PLANNING COMMISSION PUBLIC HEARING

File No: SP 23-01 & PA 23-01

Site Development Review and Partition for Pure Energy Group

PRELIMINARY CIVIL SITE PLAN
 PURE ENERGY GROUP
 TAX LOT 1200, MAP 10S-3W-21D
 MILLERSBURG, OREGON

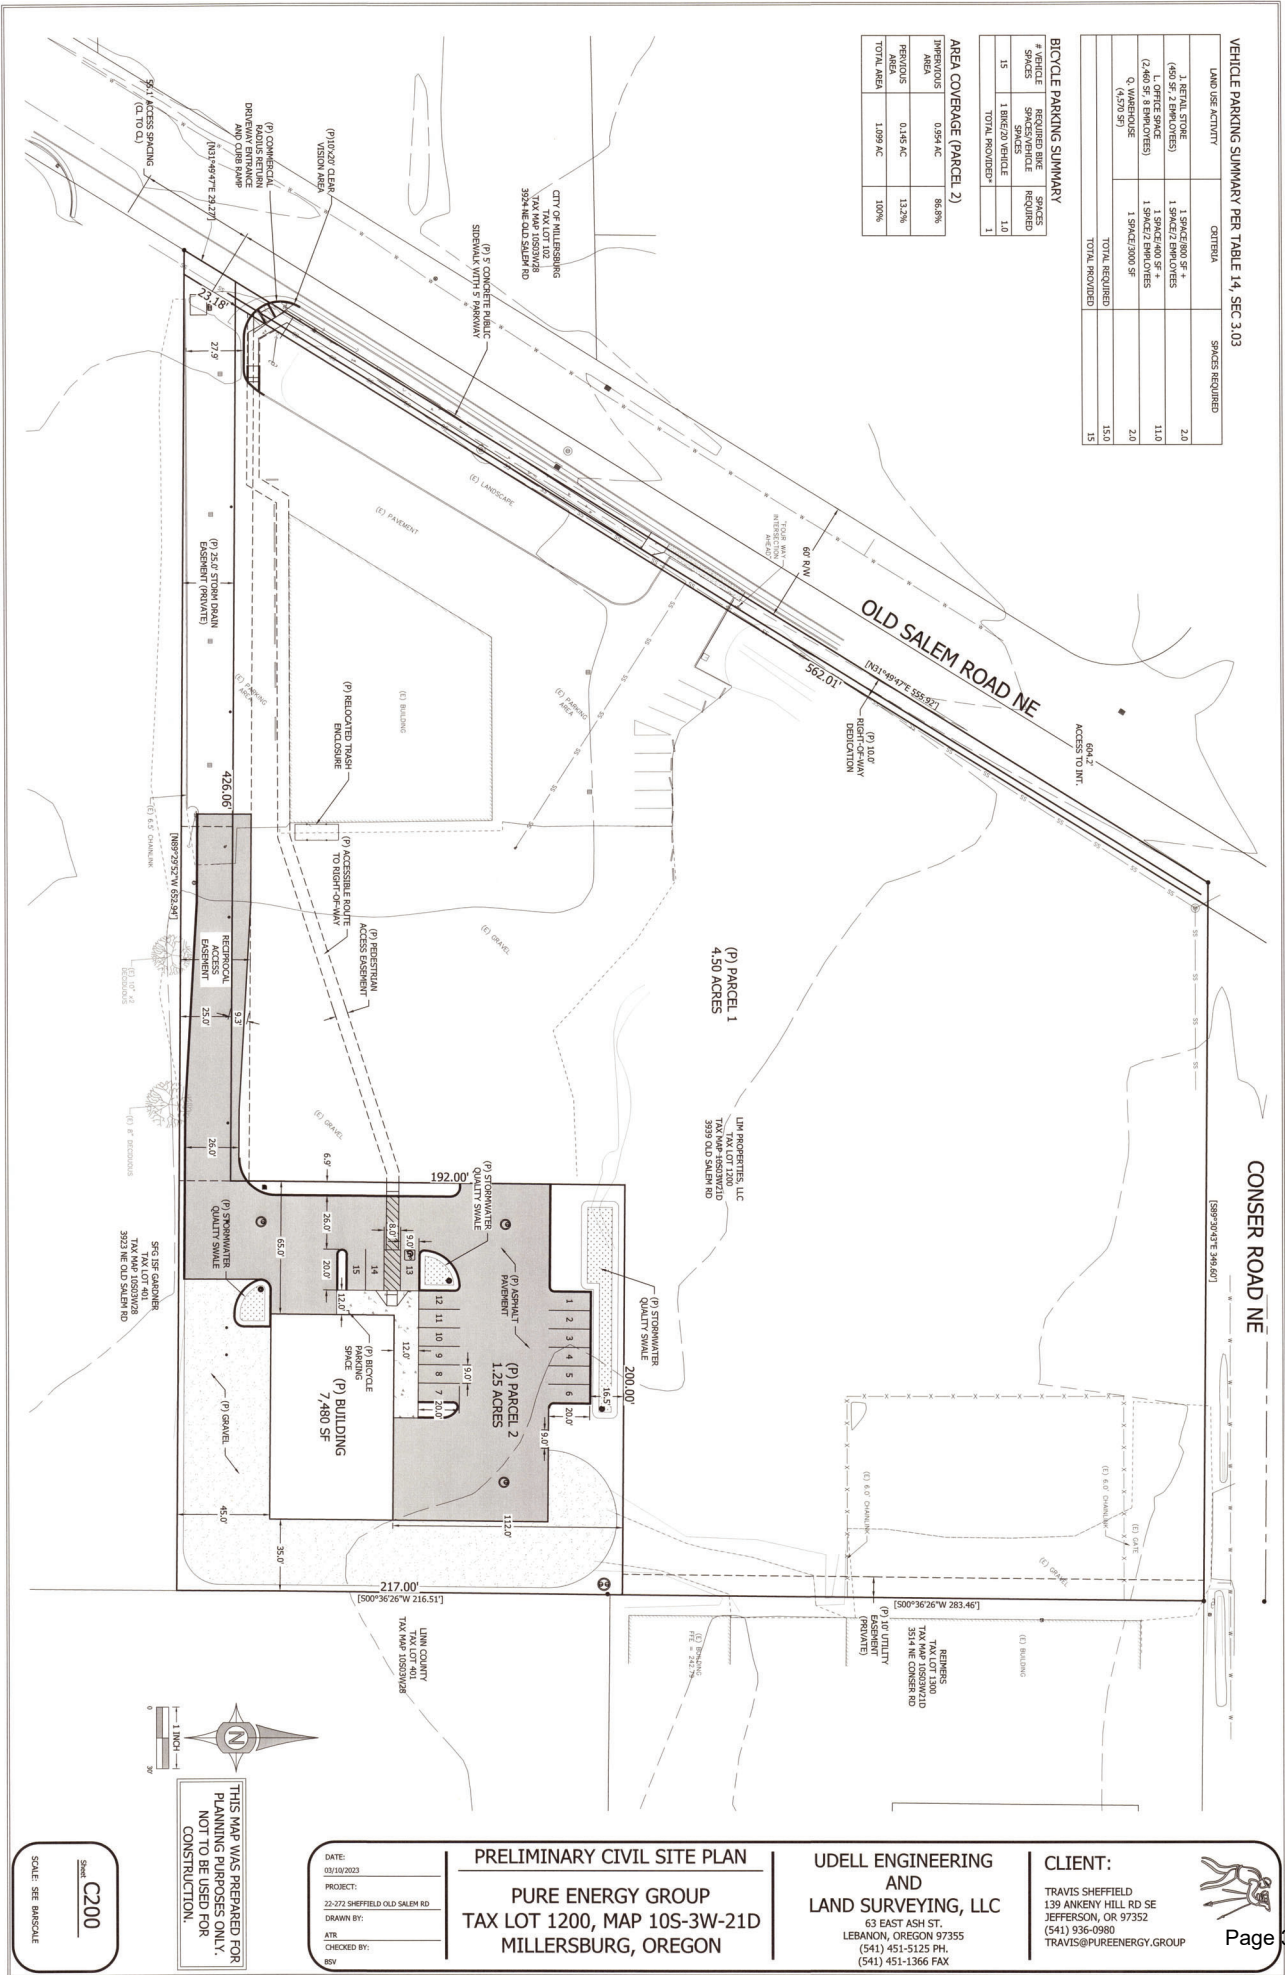
ANALYSIS: The site plan does not show any plaza area. Based on the size of the structure proposed, which is 7,480 square feet, the plaza area should be at least 70 square feet. A condition of approval has been added requiring the applicant to add a plaza to the site plan for the project. Because the location and design of the required plaza could be a discretionary interpretation, the Planning Commission may require these to be submitted prior to approving the project.

- o Prior to issuance of a building permit, the applicant shall redesign the site plan to add a plaza that is at least 70 square feet and meets the requirements of 3.26.030(8), to the satisfaction of the Community Development Director.

1
A3 / NTS
ELEVATION NORTH VIEW

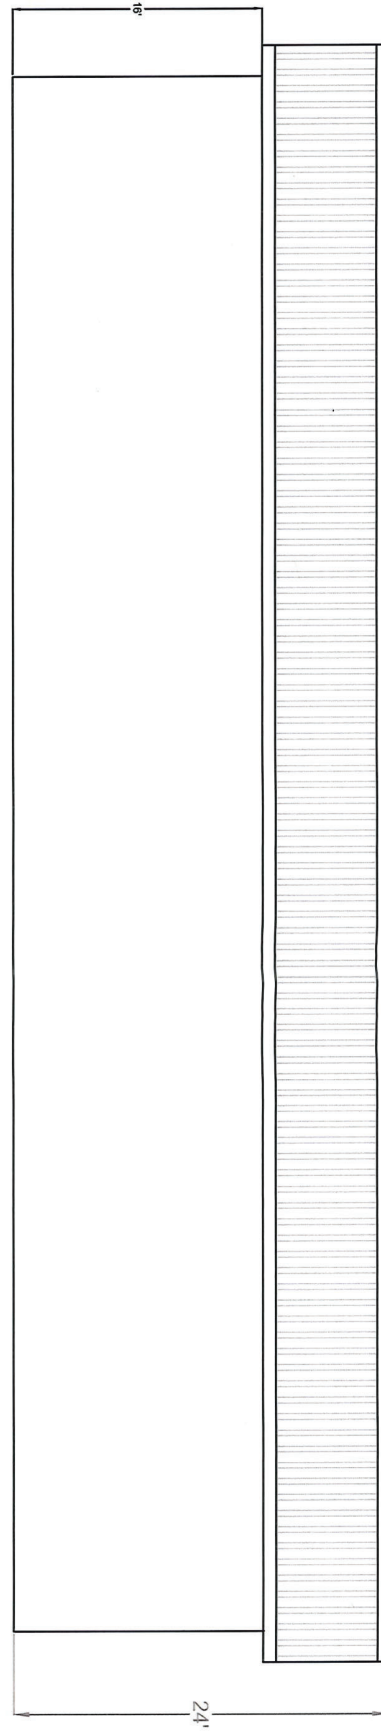
The west and north facing walls are visible from the street and therefore apply. The elevations show compliance with the windows requirements. The applicant's narrative explains that a 2/12 roof pitch and combinations of wall finishes show compliance. Covered awnings are included as well. The Code further requires that at least 50% of the walls length include

architectural features and landscaping. As submitted, the west wall meets this requirement, the north wall does not appear to meet the requirement. It seems all architectural features cover only about 40% of the wall length. Additionally, it is not clear if the landscaping will cover 50% of the wall length because landscape plans were not provided. Conditions of approval have been added. Because this requirement may be a discretionary interpretation, the Planning Commission may require these to be submitted prior to approving the project.

- Prior to building permit issuance, the building plans for the north façade shall be revised to include architectural features along at least 50% of the wall length, to the satisfaction of the Community Development Director.
- The north and west facing wall of the structure shall include landscaping along the façade of the structure for at least 50% of the wall length (abutting the building), to the satisfaction of the Community Development Director.
